DART AEROSPACE LTD HAWKESBURY, ONTARIO, CANADA	
DRAWING NO. D206-667-247	REV. A SHEET 1 OF 4
TITLE CROSSTUBE ASS'Y (206L MID AFT)	SCALE NTS
COPYRIGHT © 2018 BY DART AEROSPACE LTD THIS DOCUMENT IS PRIVATE AND CONFIDENTIAL AND IS SUPPLIED ON THE EXPRESS CONDITION THAT IT IS NOT TO BE USED FOR ANY PURPOSE OR COPIED OR COMMUNICATED TO ANY OTHER PERSON WITHOUT WRITTEN PERMISSION FROM DART AEROSPACE LTD.

DRAWING NO. D206-667-247	TITLE CROSSTUBE ASS'Y (206L MID AFT)	REV. A	DART AEROSPACE LTD ENGINEERING ORDER		D.E.O. NO. D206-667-247-A-1	SHEET NO. SHEET 1 OF 1	SCALE NTS
DRAWN <i>qf</i>	CHECKED <i>ASS</i>	MFG. APPR. <i>AD</i>	APPROVED <i>JMP</i>		DE APPR. <i>HA</i>		
DATE 11.07.15	DATE 11.07.20	DATE 11.07.21	DATE 11/07/21		DATE 11.07.21

PURPOSE:

REPLACE MAGNOBOND WITH PROSEAL.

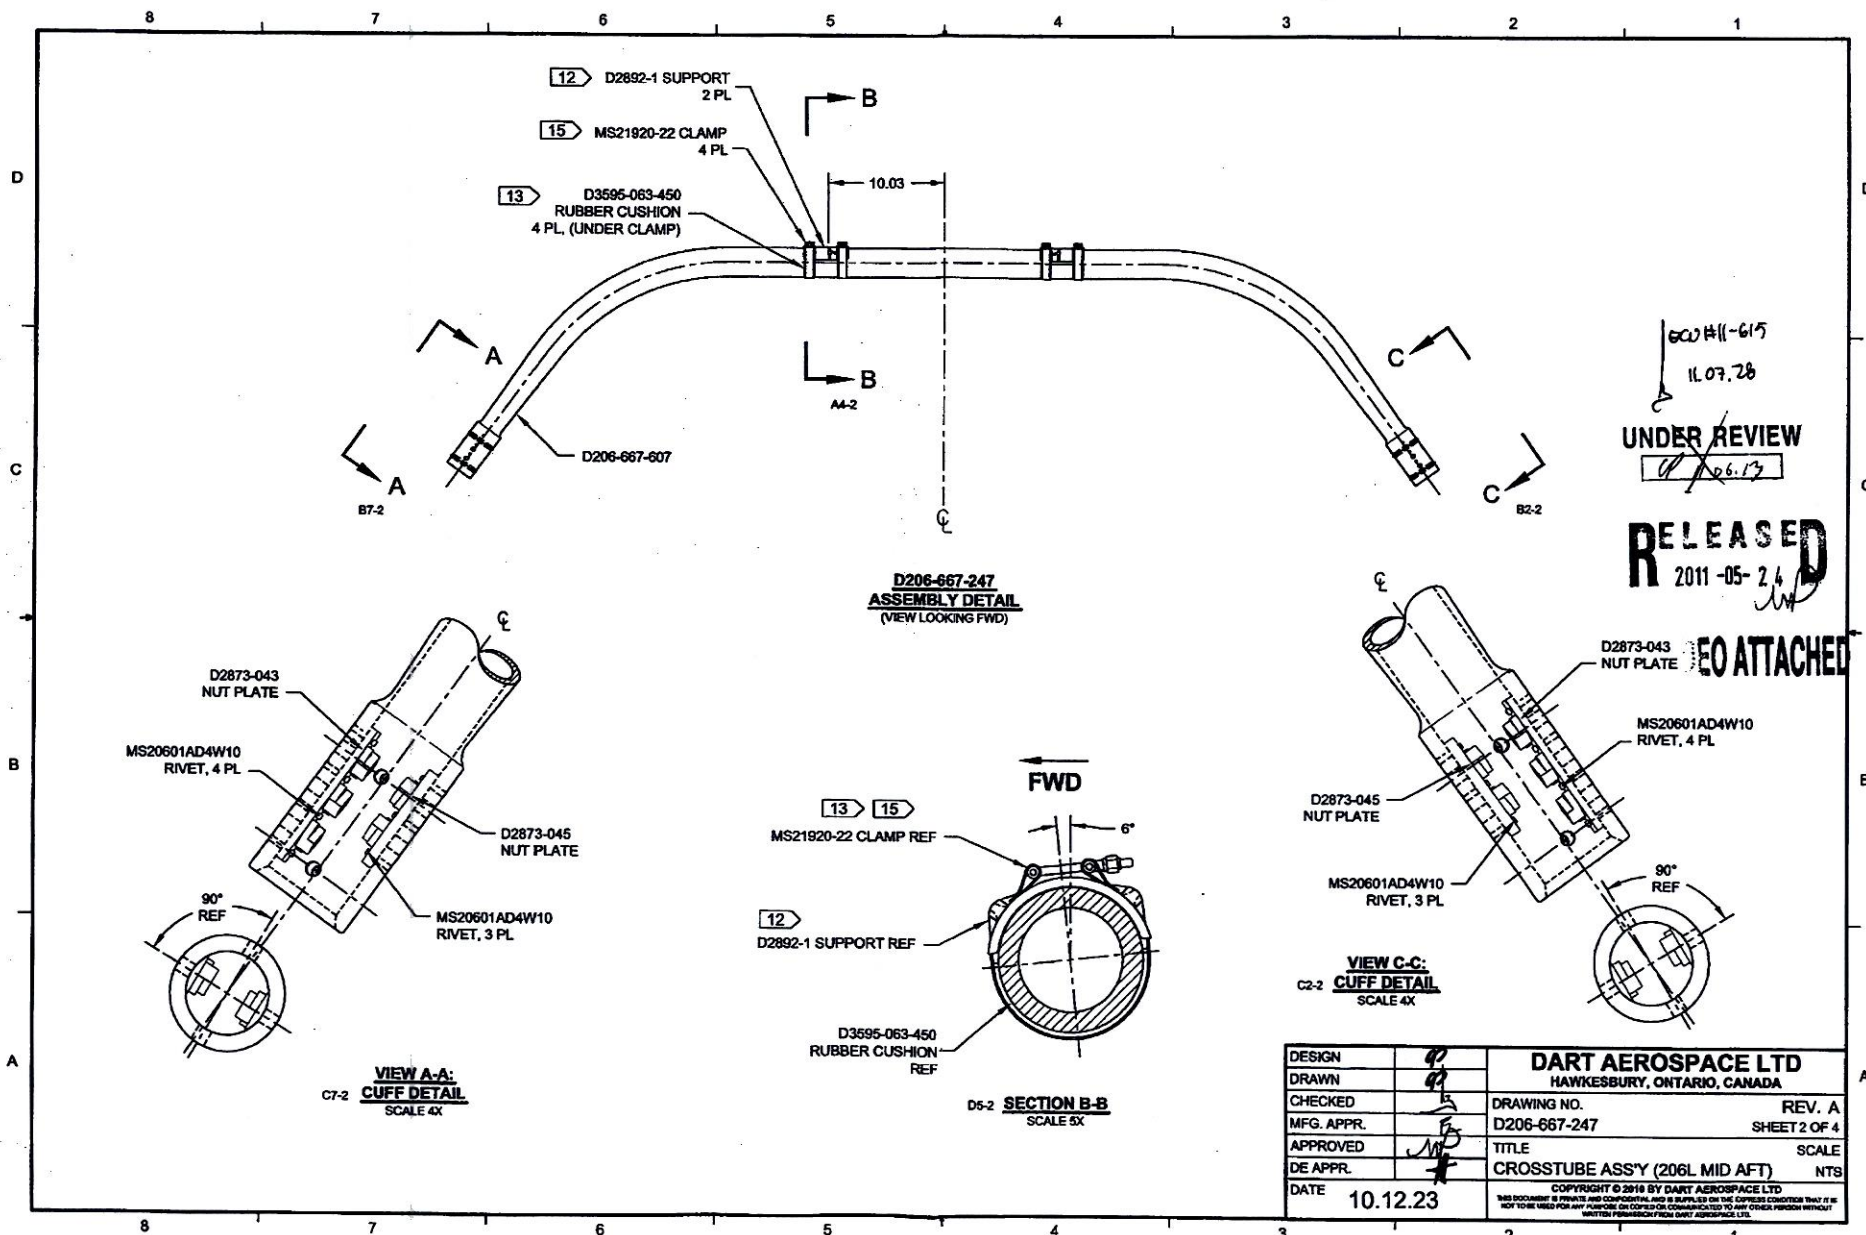
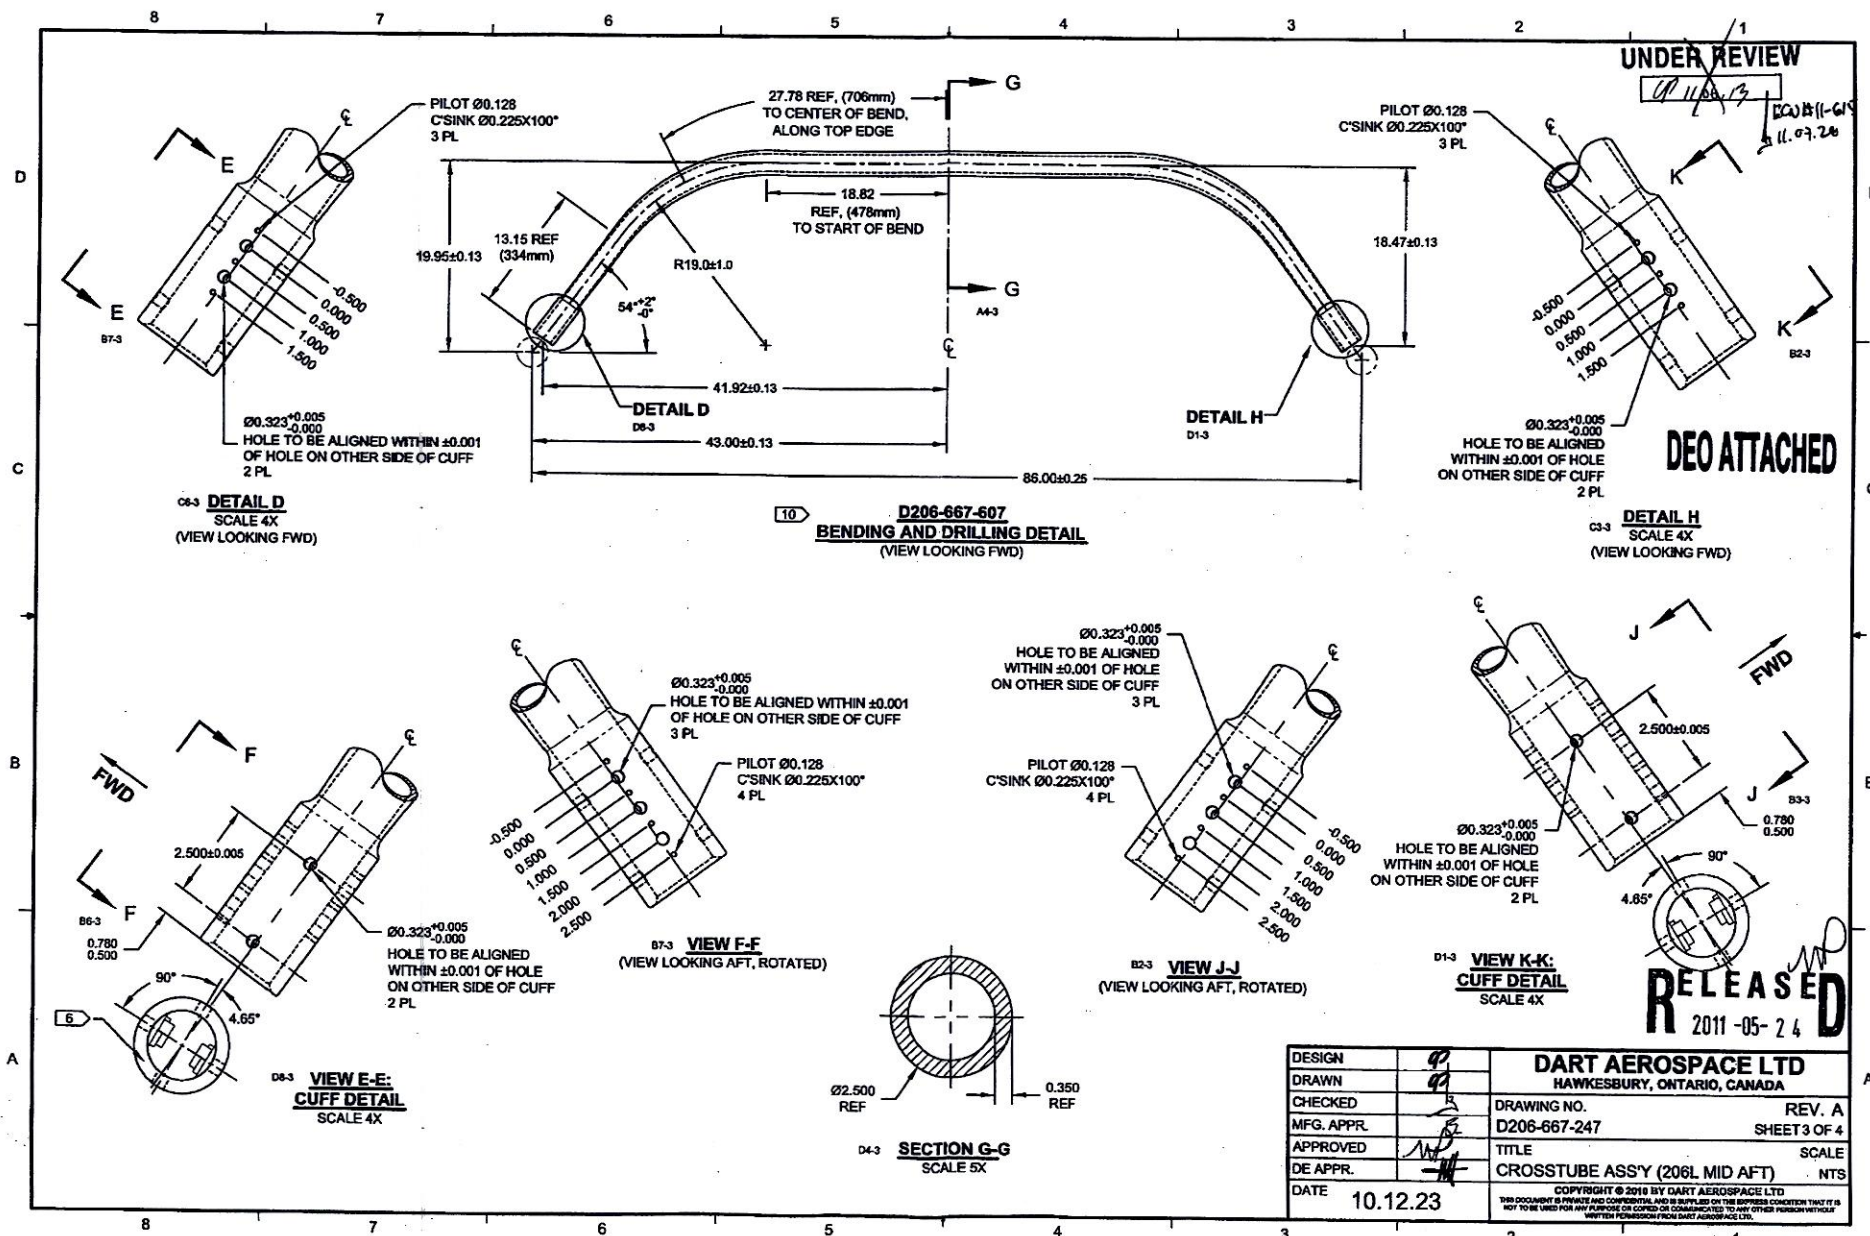
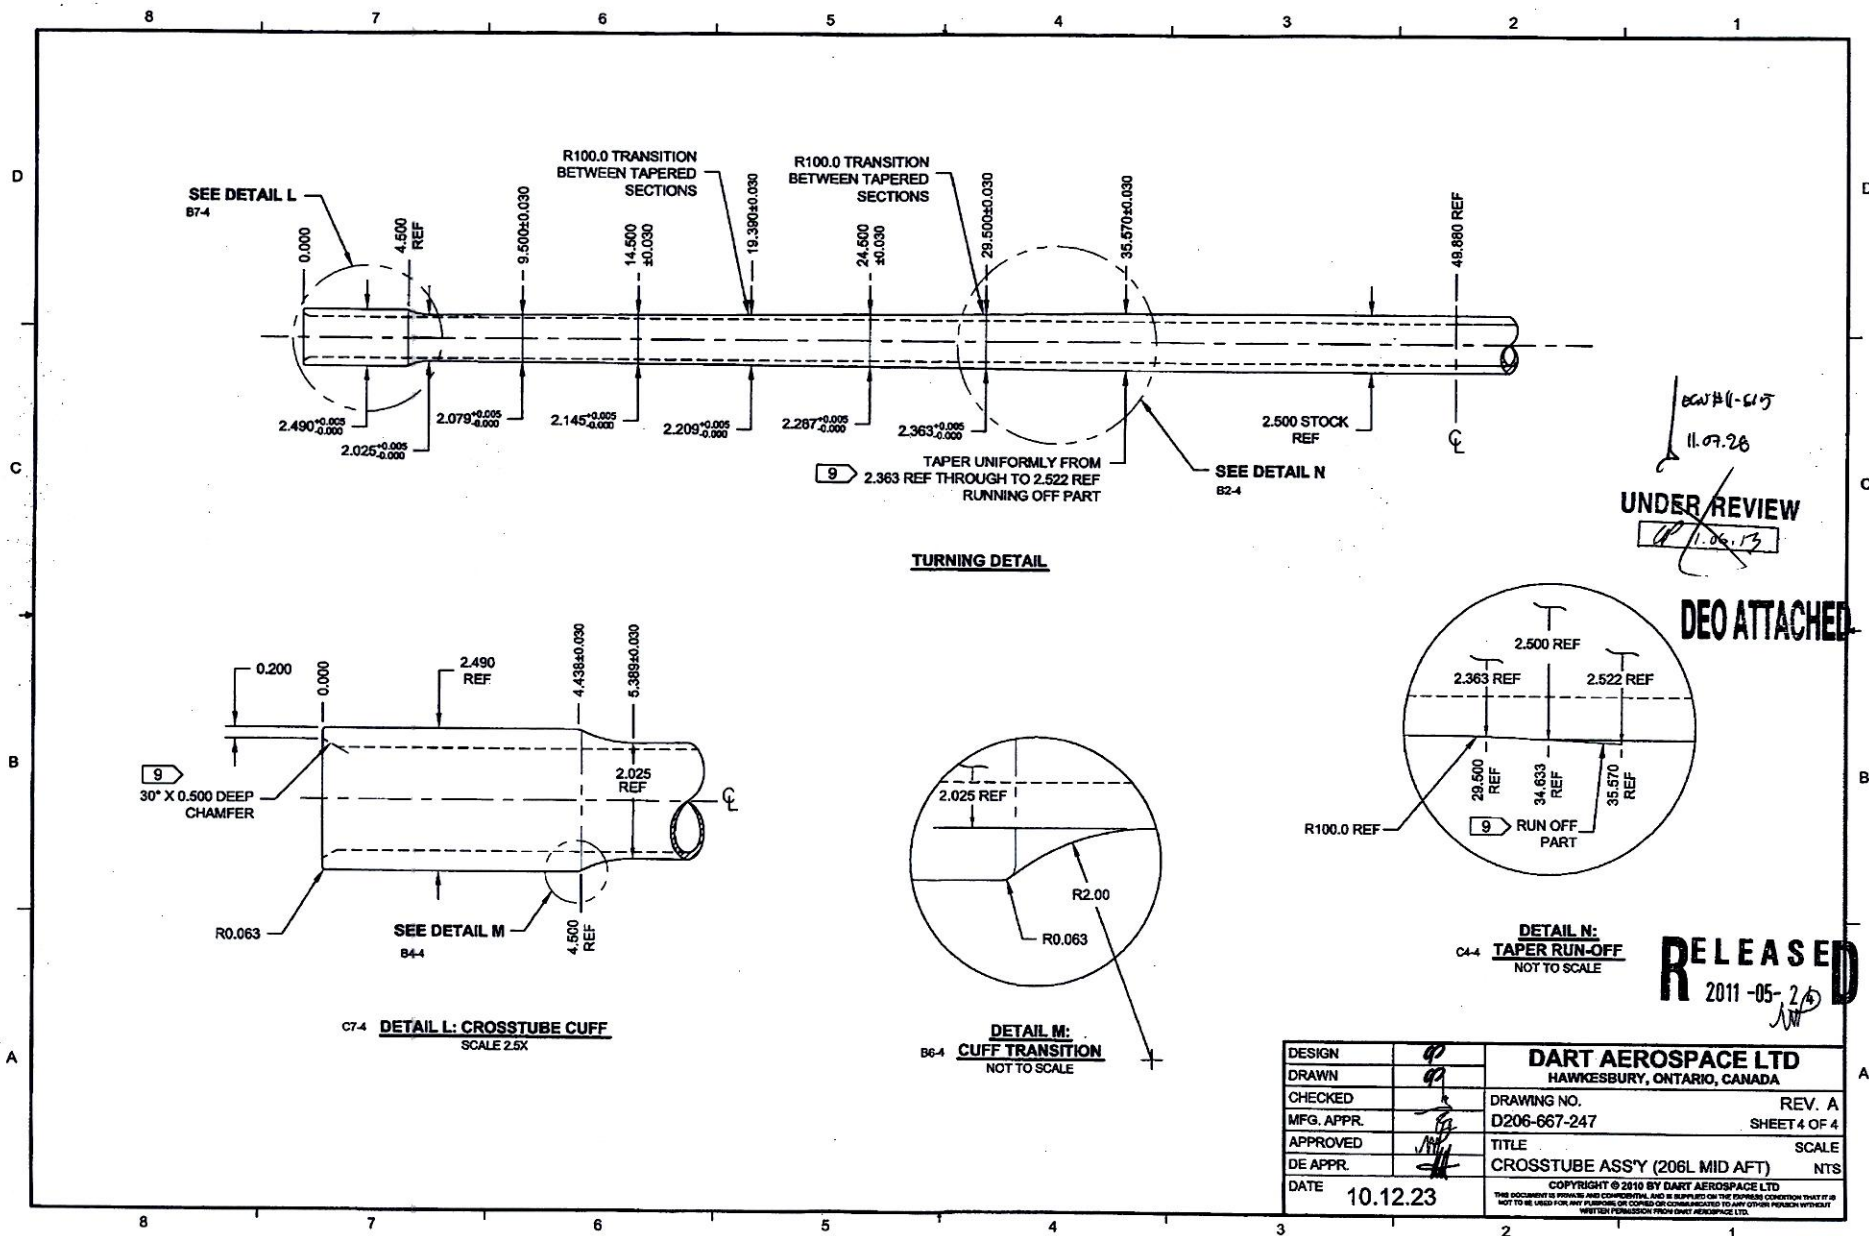
IS:

Item	Qty -247	Part Number	Description
9	A/R	PROSEAL 890 B-2	SEALANT, AMS-S-8802 CLASS B-2

WAS:

9	A/R	MAGNOBOND 6398	ROCKWELL SPECIFICATION RBO-120-023 ADHESIVE (TEXTRON/BELL SPEC. 299-947-100, TYPE II, CLASS 2 ADHESIVE)
---	-----	----------------	---

NOTE 12 & 15, SHEET 1 IS AMENDED AS FOLLOWS:

- 12) TO INSTALL D2892-1 SUPPORT: ABRASE MATING SURFACE OF SUPPORT AND CROSSTUBE WITH 180-GRIT SANDPAPER AND REMOVE RESIDUE WITH MEK (OR EQUIVALENT). APPLY A 0.04" TO 0.07" THICK LAYER OF PROSEAL 890 CLASS B-2 (OR AMS-S-8802 CLASS B-2) SEALANT TO MATING SURFACE OF SUPPORT.
- 15) TORQUE CLAMPS 80 TO 100 IN-LB. ENSURE AT LEAST 1.5 THREADS SHOWING IN SAFETY AND THAT NUT HAS NOT BOTTOMED-OUT AFTER TORQUING. **PRIOR TO PACKAGING, RE-CHECK TORQUE ON CLAMPS AFTER PROSEAL 890 SEALANT HAS CURED FOR 72 HOURS.**

- 12) INSTALL D2892-1 SUPPORT USING 0.03" TO 0.06" THICK LAYER OF MAGNOBOND 6398 PER QSI 015. LET CURE FOR 12 HOURS AFTER INSTALLATION AND PRIOR TO PACKAGING.
- 15) TORQUE CLAMPS 80 TO 100 IN-LB. ENSURE AT LEAST 1.5 THREADS SHOWING IN SAFETY AND THAT NUT HAS NOT BOTTOMED-OUT AFTER TORQUING.
